RESOURCE CONSERVATION AND RECOVERY ACT
TEN-YEAR RENEWAL APPLICATION
FOR THE
WASTE ISOLATION PILOT PLANT
HAZARDOUS WASTE FACILITY PERMIT

Prepared by the
U.S. Department of Energy, Carlsbad Field Office
and
Nuclear Waste Partnership LLC

March 2020

Summary of Proposed Changes

Figure D-6-NFB
WIPP On-Site Assembly Areas and Off-Site Staging Areas with Building 416

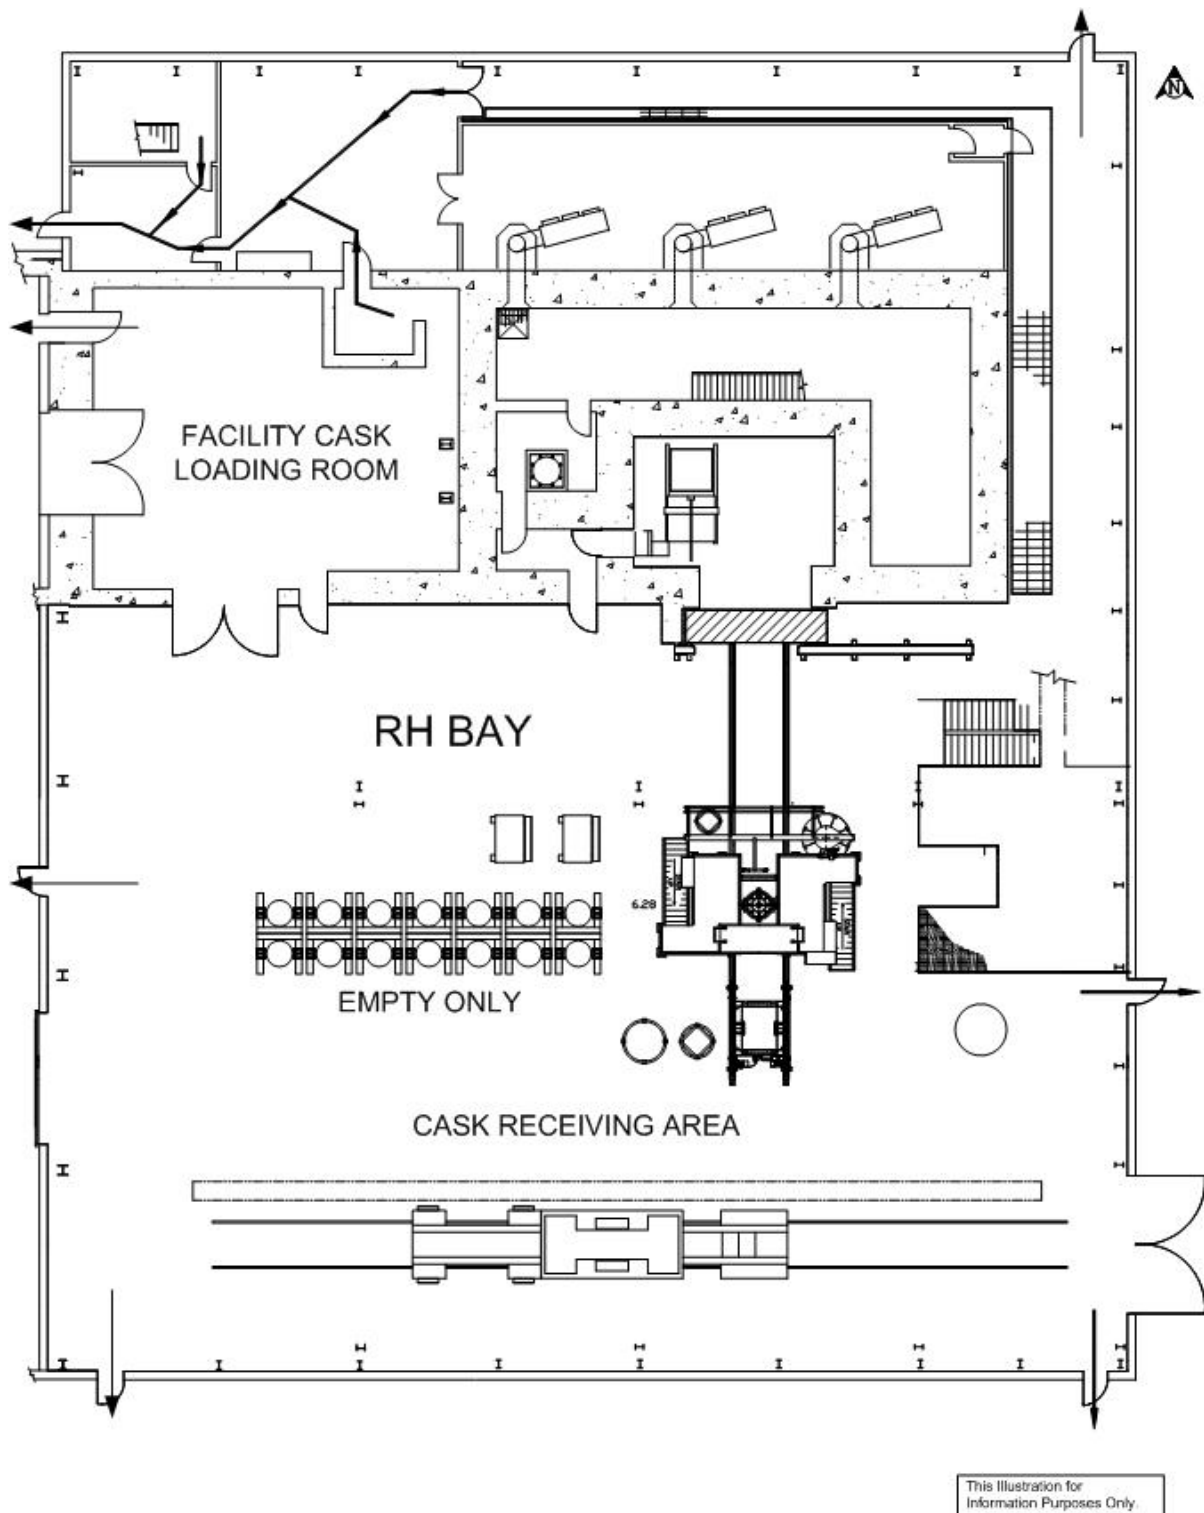
Renewal Application Section	Description of Change(s)	Discussion
System with Building 416		
Figure D-6 WIPP On-Site Assembly Areas and Off-Site Staging Areas	Figure removed; this information is being moved to Figure D-1 with exception to the eye wash locations and the "E" symbol in the legend. Eyewash equipment locations are specifically described in Table D-2. The "E" designation in the legend was not used in the figure. Exit locations for the Waste Handling Building are depicted in Figures 6a through 6c. Change text references from Figure D-6 to Figure D-1.	Streamline the Renewal Application and ensure its accuracy and readability.
Figure D-6-NFB WIPP On-Site Assembly Areas and Off-Site Staging Areas with Building 416	Figure removed; this information is being moved to Figure D-1-NFB with exception to the eye wash locations and the "E" symbol in the legend. Eyewash equipment locations are described specifically in Table D-2. The "E" designation in the legend was not used in the figure. Exit locations for the Waste Handling Building are depicted in Figures 6a through 6c. Change text references from Figure D-6-NFB to Figure D-1-NFB.	Streamline the Renewal Application and ensure its accuracy and readability.

Figure G-5
Typical Disposal Panel

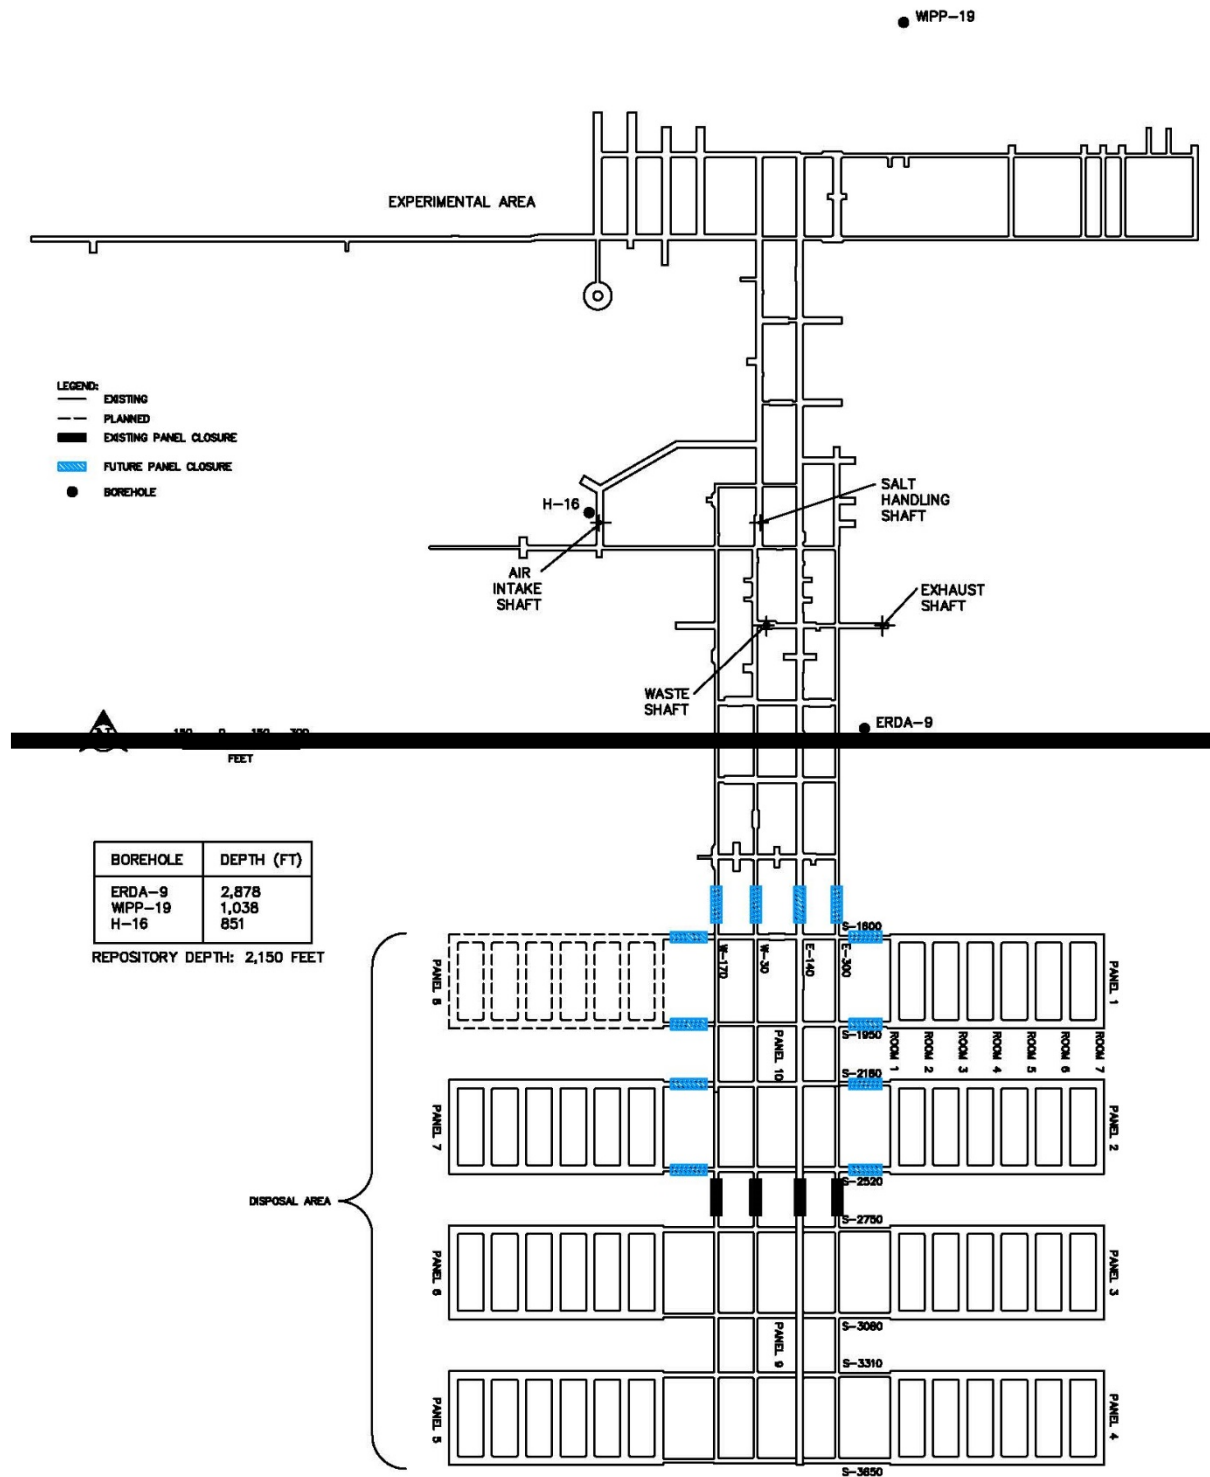
Renewal Application Section	Description of Change(s)	Discussion
Barrier and Bulkhead		
Permit Figure G-5 Typical Disposal Panel	Combined with Permit Attachment A3 and moved to Attachment M, Figure M-42.	Streamline the Renewal Application and ensure its accuracy and readability.
Permit Figure G-6 Approximate Locations of Boreholes in Relation to the WIPP Underground	Combined with Figures A2-1, A4-4a, A4-4, and G-1 and moved to Attachment M, Figure M-43; changed title to "Repository Horizon and Underground Waste Transport Routes."	Streamline the Renewal Application and ensure its accuracy and readability.
Attachment G1 WIPP Panel Closure Design Description and Specifications		
General	Global editorial changes described above.	Ensure accuracy and enhance the readability of the Renewal Application.
Section G1-2 WPC Description	Added "with ROM salt" and "as the closures for Panels 3 through 6" to description of WPC-A.	Ensure the completeness and accuracy of the Renewal Application; the revision reflects closure for Panels 3, 4, 5, and 6 allowed by Attachment G.

Figure L-6
Detection Monitoring Well Locations

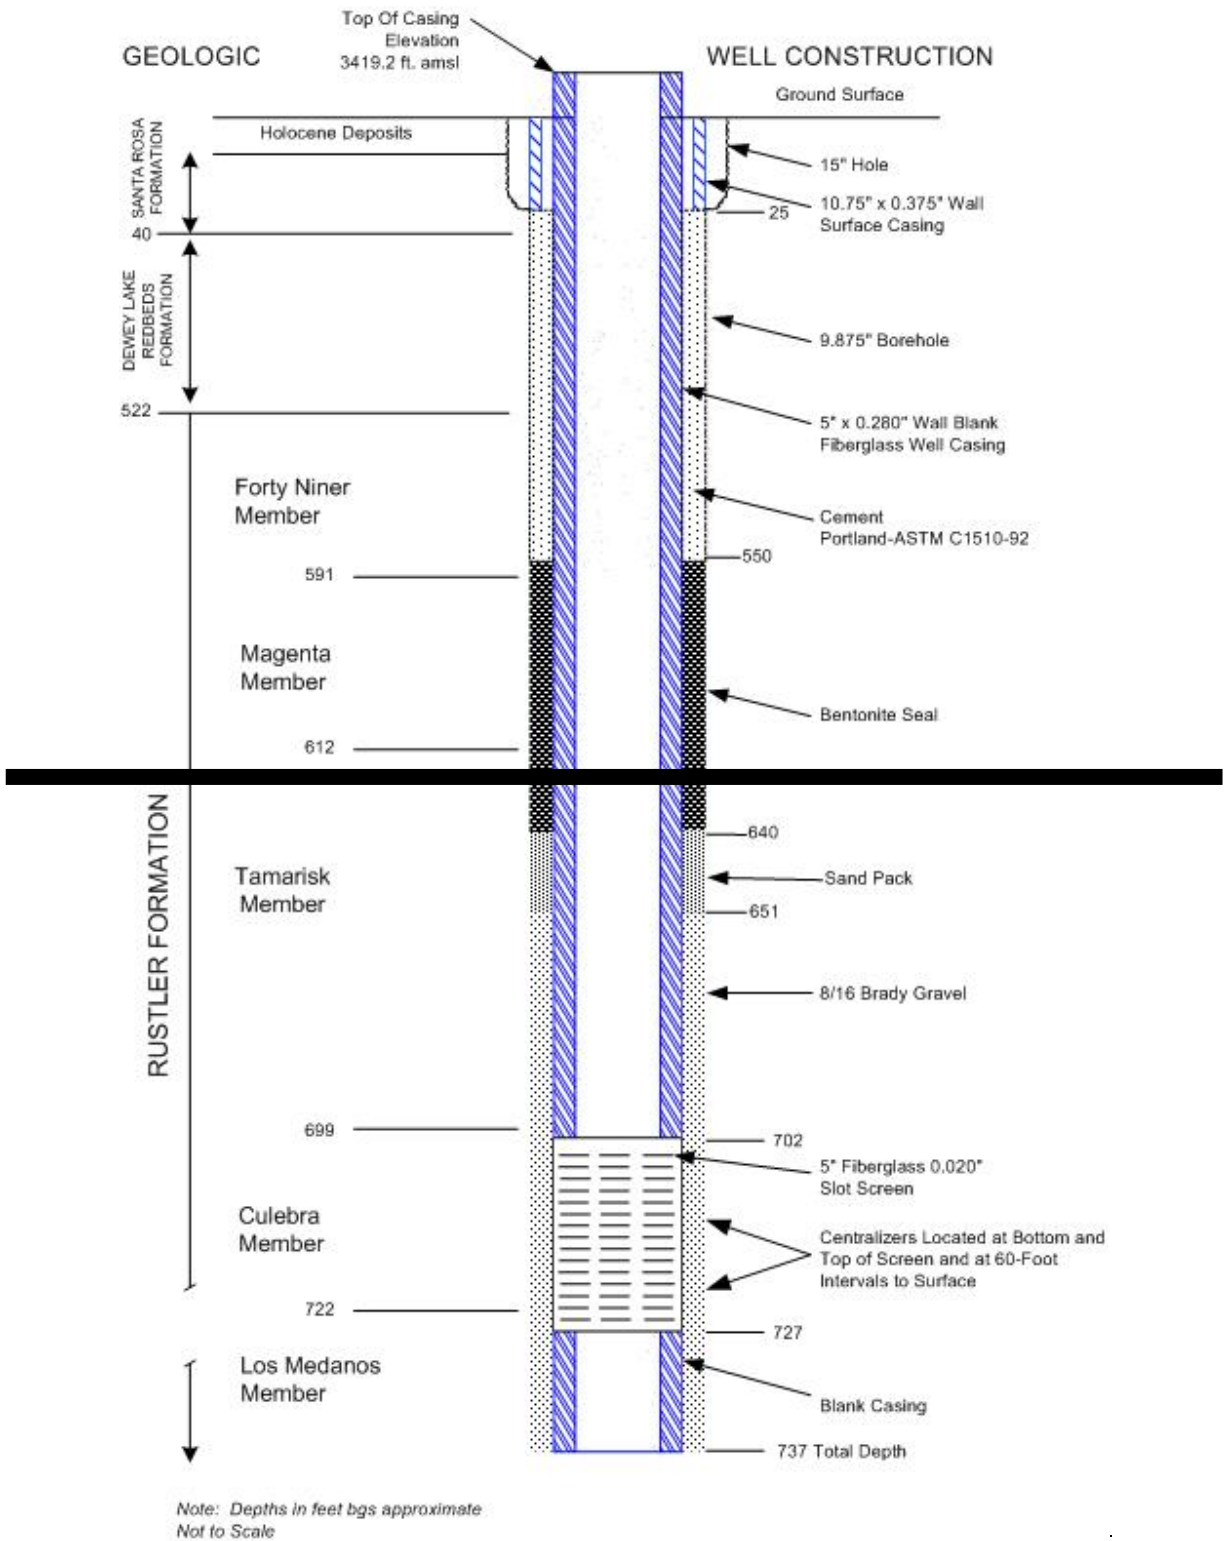
Renewal Application Section	Description of Change(s)	Discussion
Permit Figure L-6 Detection Monitoring Well Locations	Moved to Attachment M, Figure M-69.	Streamline the Renewal Application and ensure its accuracy and readability.
Permit Figure L-7 As-Built Configuration of Well WQSP-1	Moved to Attachment M, Figure M-70.	Streamline the Renewal Application and ensure its accuracy and readability.
Permit Figure L-8 As-Built Configuration of Well WQSP-2	Moved to Attachment M, Figure M-71.	Streamline the Renewal Application and ensure its accuracy and readability.
Permit Figure L-9 As-Built Configuration of Well WQSP-3	Moved to Attachment M, Figure M-72.	Streamline the Renewal Application and ensure its accuracy and readability.
Permit Figure L-10 As-Built Configuration of Well WQSP-4	Moved to Attachment M, Figure M-73.	Streamline the Renewal Application and ensure its accuracy and readability.
Permit Figure L-11 As-Built Configuration of Well WQSP-5	Moved to Attachment M, Figure M-74.	Streamline the Renewal Application and ensure its accuracy and readability.

Figure L-12
As-Built Configuration of Well WQSP-6

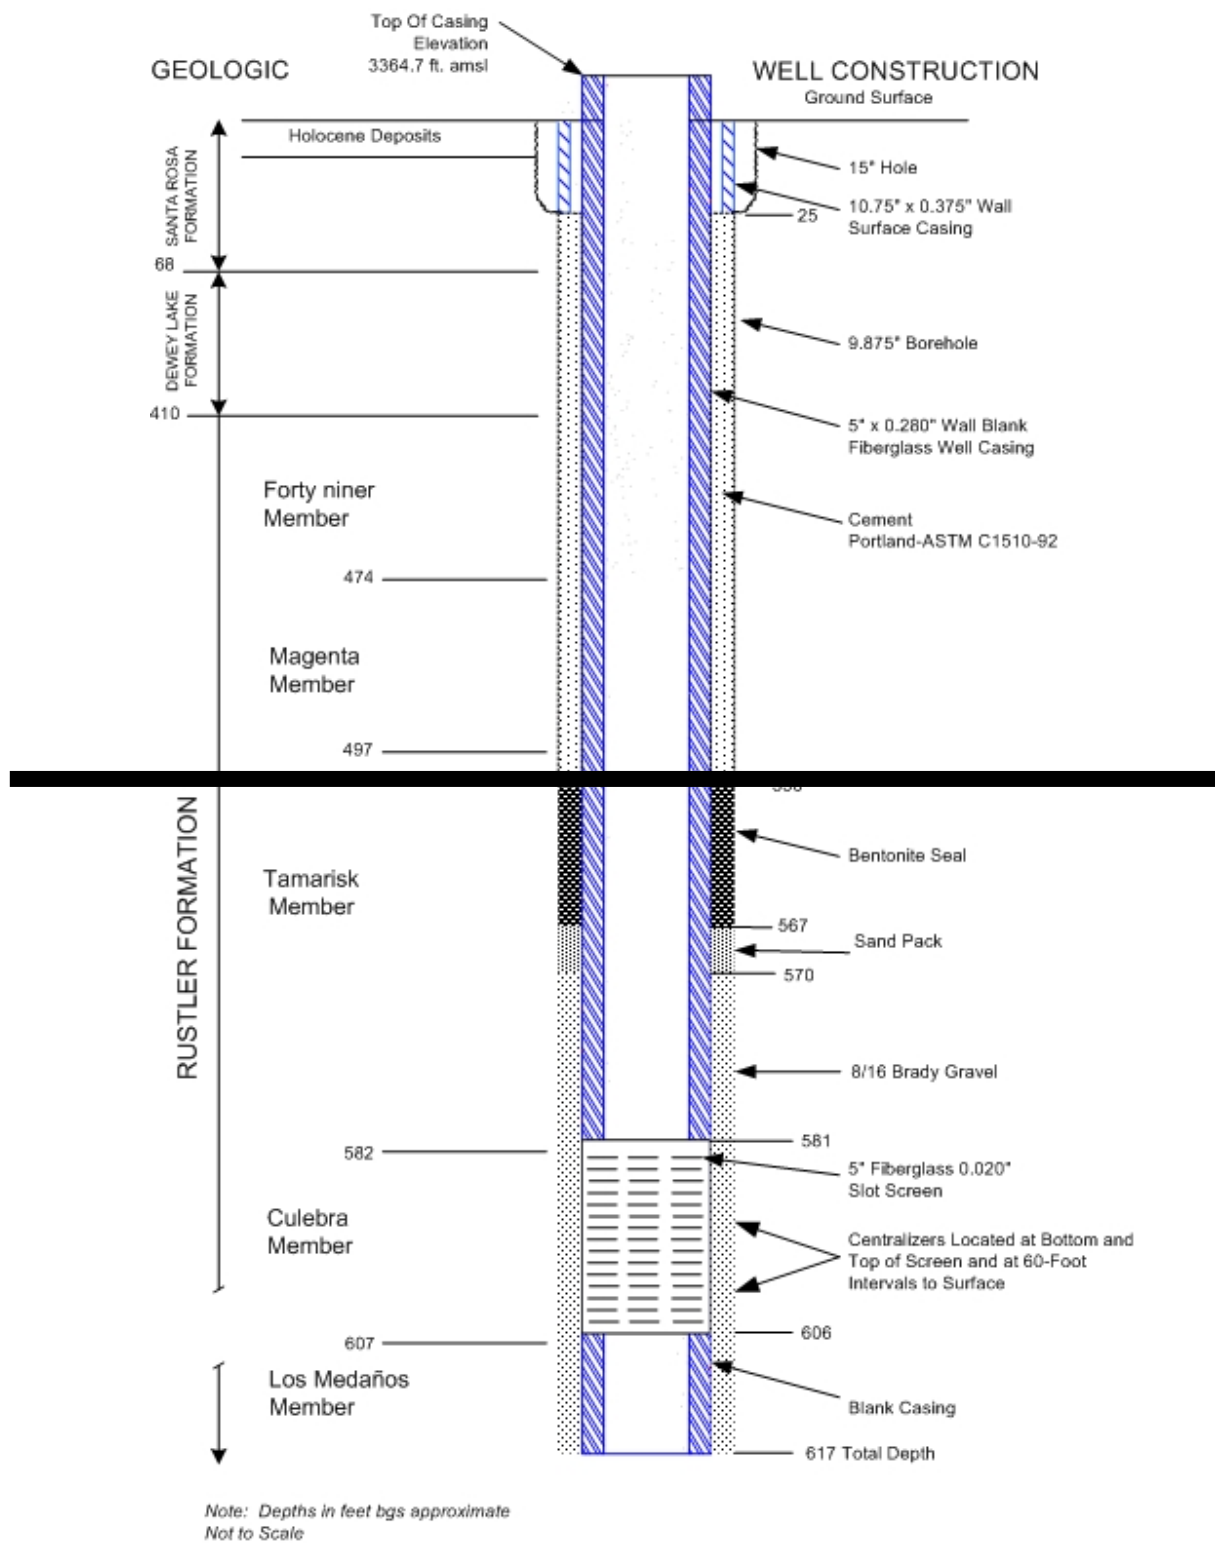
Permit Figure L-12 As-Built Configuration of Well WQSP-6	Moved to Attachment M, Figure M-75.	Streamline the Renewal Application and ensure its accuracy and readability.
Permit Figure L-13 Example Chain of Custody/Request for Analysis Form	Removed figure.	Removed unnecessary detail that does not support a Permit requirement and is not required by the New Mexico Hazardous Waste Management Regulations.
Permit Figure L-14 Groundwater Level Surveillance Wells (inset represents the groundwater surveillance wells in WIPP Land Withdrawal Area)	Moved to Attachment M, Figure M-76.	Streamline the Renewal Application and ensure its accuracy and readability.
Attachment N Volatile Organic Compound Monitoring Plan		
General	Global editorial changes described above.	Ensure accuracy and enhance the readability of the Renewal Application.
